**Planning
Authority
Agenda**

12 October 2021

5.1 Development Application - DA 2021 / 00231 for Outbuilding at 48 Haskell Road, Brighton:

Figure 3. Building envelope for internal lots as required by clause 8.4.2 A3(a)

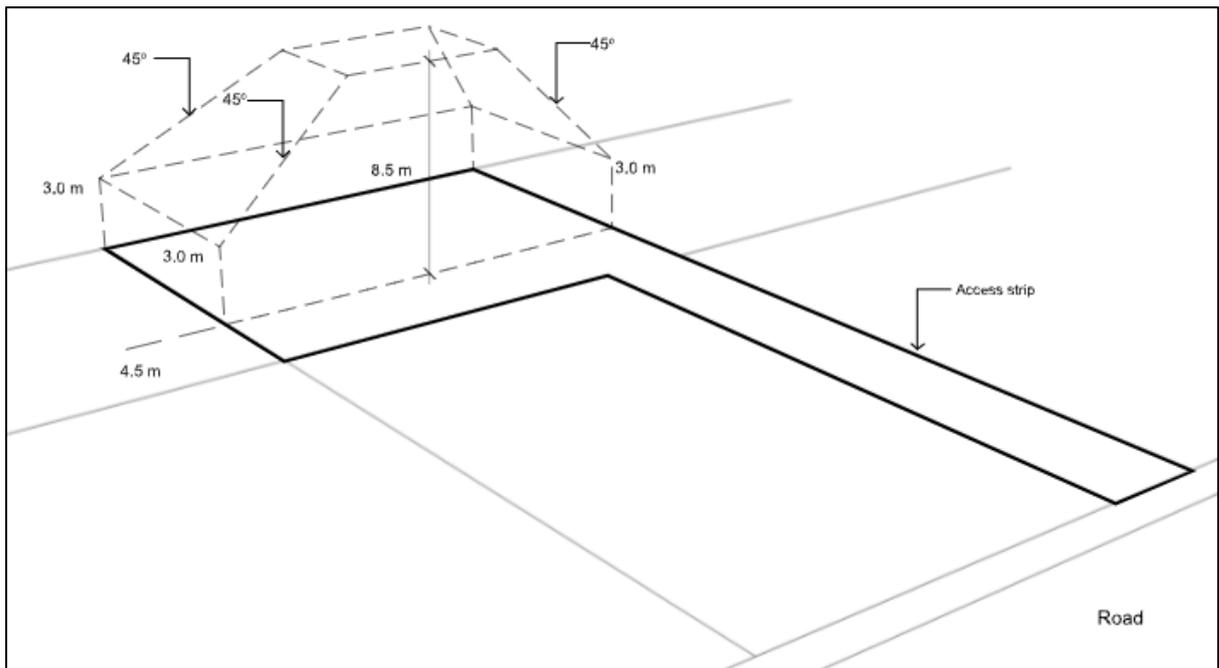
The outbuilding is proposed within the building envelope stipulated under Acceptable Solution sub-clause A3 (a) (see Figure 3 below).

However, the proposed outbuilding is setback 0.3m from the west side boundary. It is also 9m in length, which is slightly over one third of the 25.47m long side boundary. Therefore, Acceptable Solution sub-clause A3 (b) is not met, and assessment against the performance criteria is relied upon.

The outbuilding as proposed will not unreasonably overshadow a habitable room, private open space or solar panels on adjoining property. The building is also of a size and design where appearance is not considered to result in unreasonable loss of visual amenity.

The minimal side boundary setback between dwellings and/or outbuildings on adjoining properties is also consistent with that existing in the area. The adjoining lot to the west side boundary in question (50 Haskell Rd) has a similar sized outbuilding approved with very minimal rear and side boundary setbacks.

Accordingly, the proposal is considered to meet Performance Criteria 8.4.2 P3.
